PLANNING COMMISSION REGULAR MEETING AGENDA

Wednesday, May 27, 2026
7 p.m.

5. **P26-0360 and PUD-152, 231 Old Bernal Avenue**- Applications for: (1) Planned Unit Development (PUD) Rezoning (P26-0360) to rezone the subject parcel from MU-T (Mixed Use-Transitional) District to PUD-MU-T (Planned Unit Development-Mixed Use-Transitional) District; (2) Certificate of Appropriateness to demolish an existing 6,160-square-foot commercial office building in the Downtown Revitalization District; and (3) PUD Development Plan (PUD-152) to construct a three-story, four-unit residential building on a 0.49-acre lot, with units ranging in size from 430 square feet to 13,626 square feet and associated site improvements located at 231 Old Bernal Avenue (APN: 94-156-21). The project is exempt from the California Environmental Quality Act (CEQA) pursuant to Public Resources Code Section 21080(b)(5) and CEQA Guidelines Section 15270, which statutorily exempt projects that a public agency intends to deny.

HARDSCAPE PLAN

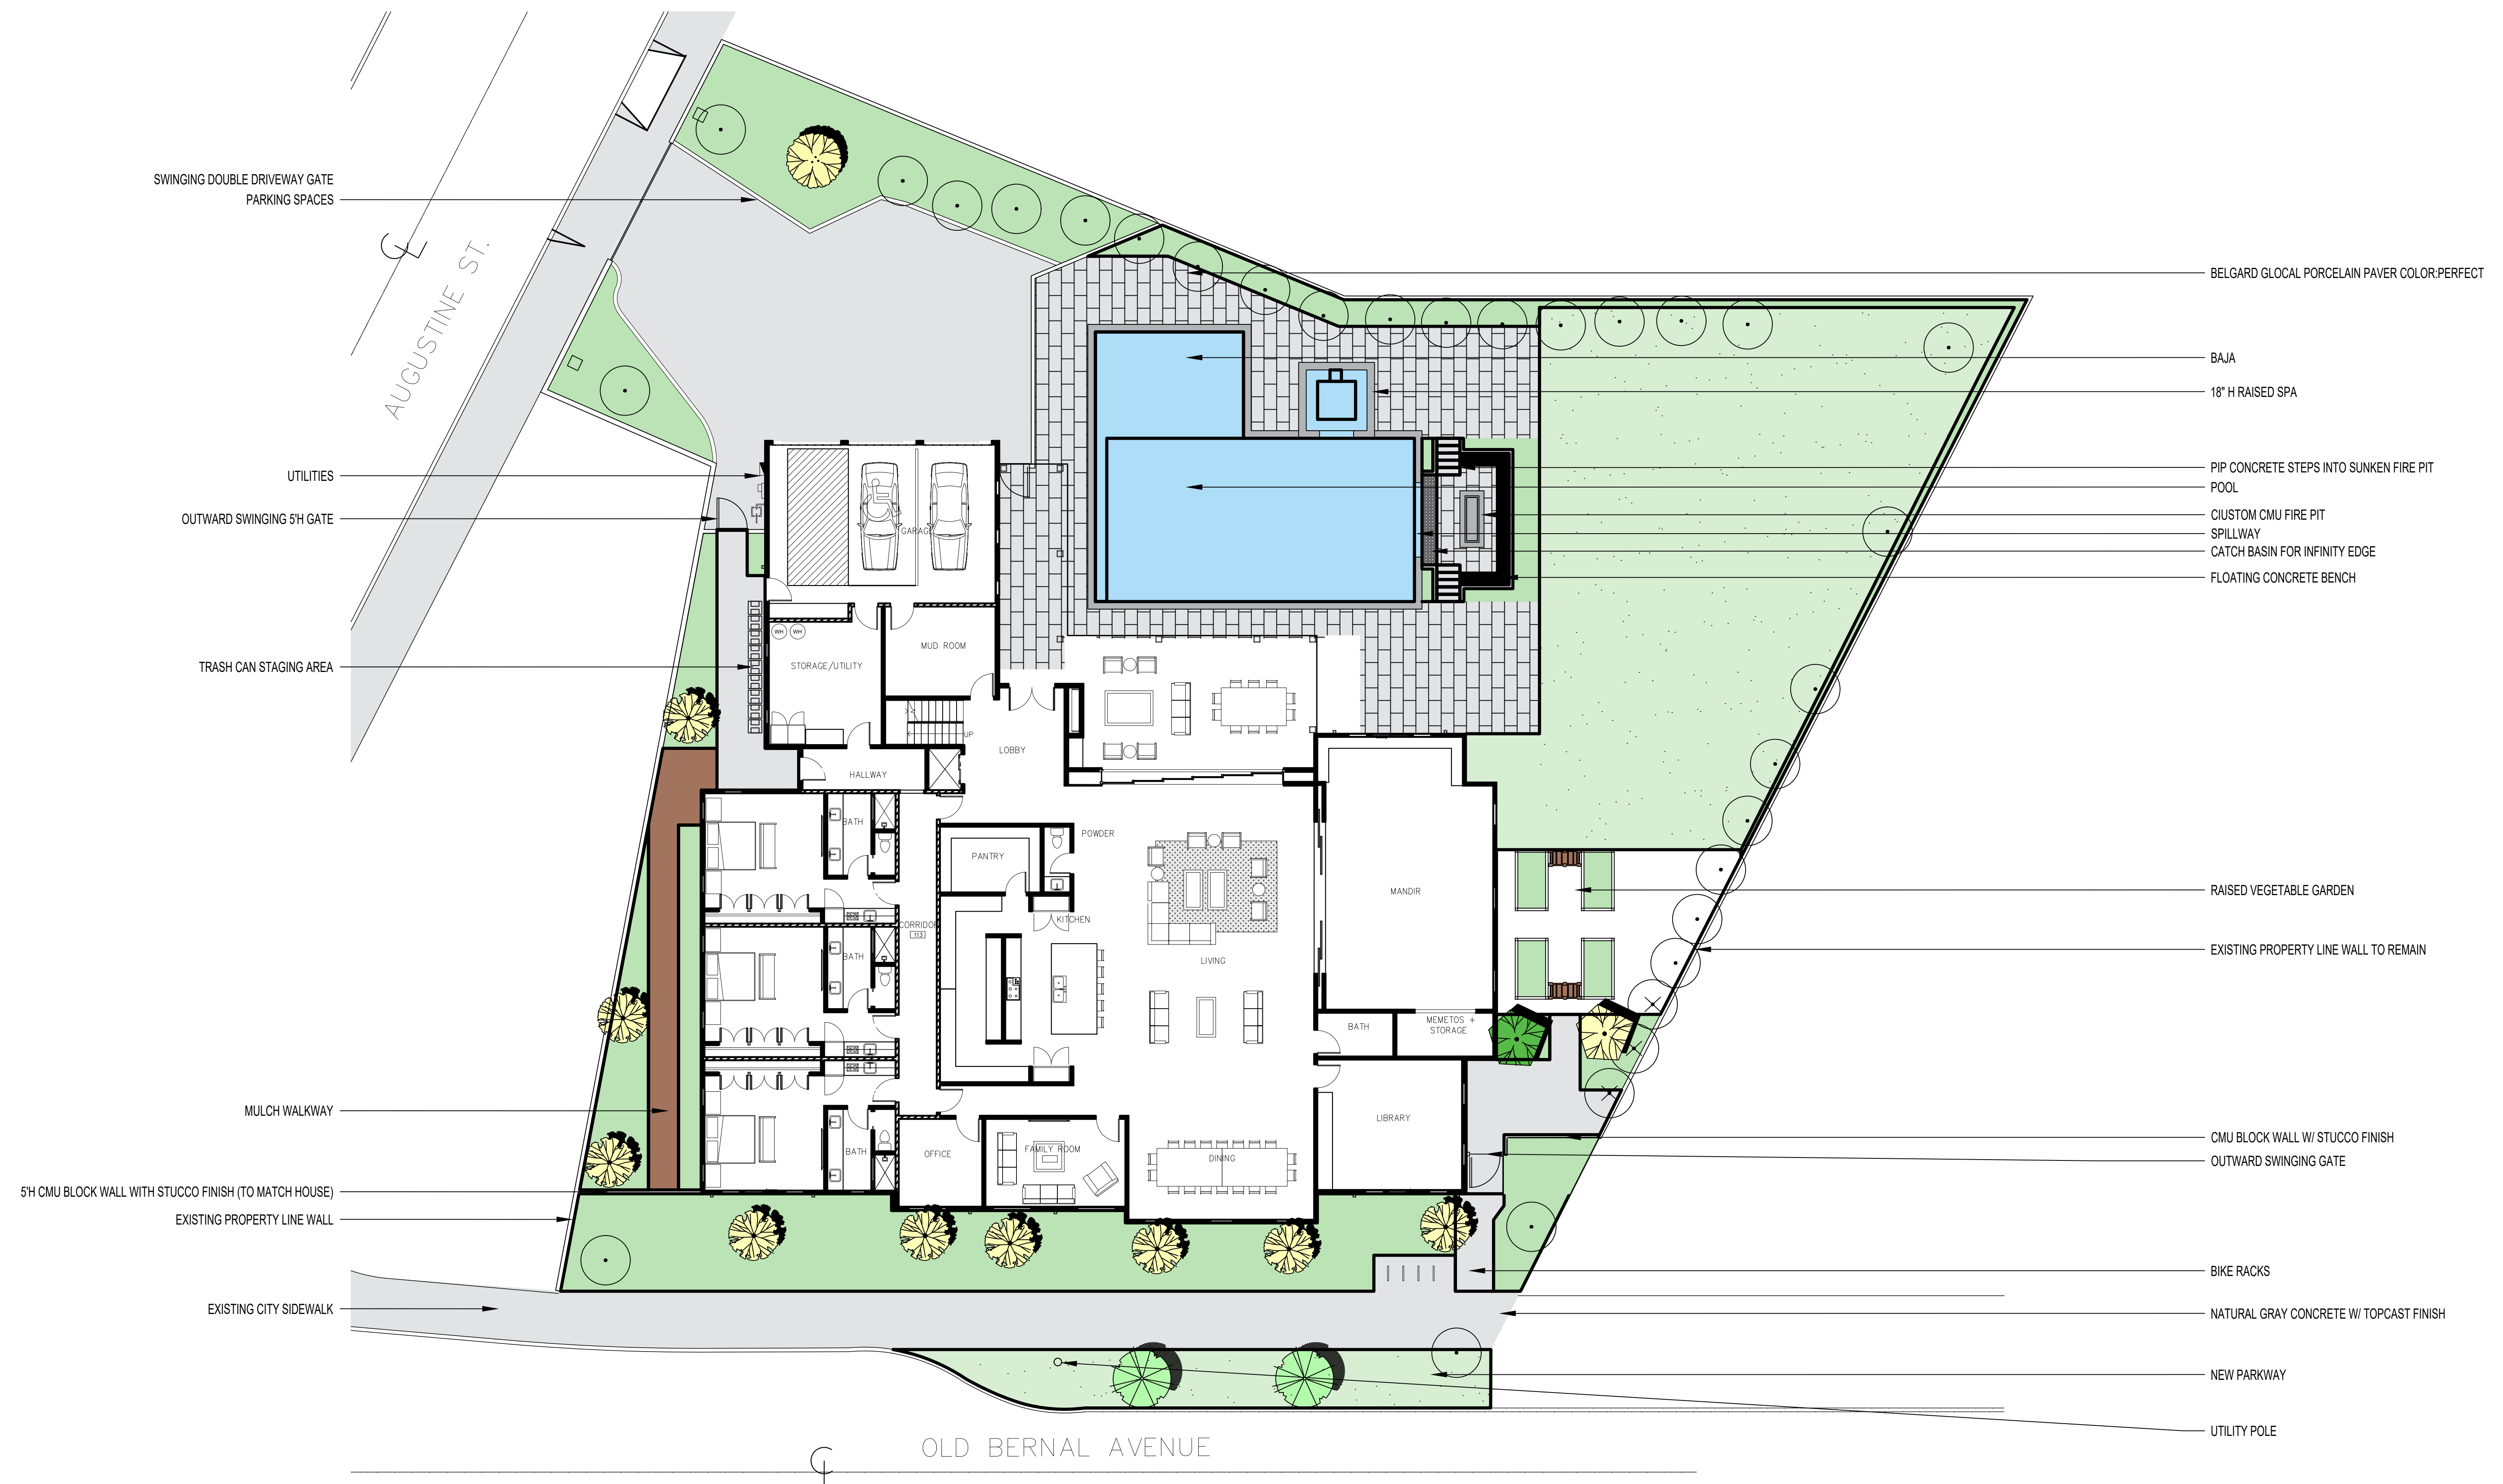
- e) Sheet A502 titled "window schedule" is blank. Please provide information.
- f) Sheet LH-1:
 - i. (Repeat) Provide height and elevation of wood trellis by the vegetable garden.

- ii. Provide elevation detail of double driveway gate. Please note that gates are to conform to the height requirement per ODS C7.6.
 - iii. Sheet indicates "Parking Spaces" for the paved area by the driveway gate. Illustrate on the plans the location of parking stalls.

- iv. Annotate how many bike parking spaces are provided in the shown bicycle parking illustration. For example, “Bicycle Parking (4 stalls, 8 spaces)”.
- v. Walkway, trash bins, and unit floor plans are not consistent throughout the plan set. (see below). Revise all plan sheets to be accurate with what the project is proposing.
 - 1. Per Pleasanton Garbage Service letter dated October 17, 2025, 12 carts for residential service are required. The number of carts is inconsistent on the plans. Sheet A100 illustrates 12 carts, but Sheet LH-1 illustrates 9 carts. Ensure consistency on all plan sheets.

- vi. Clarify the following solid linework by the east side gate (address in Civil/Landscape sheets as well):
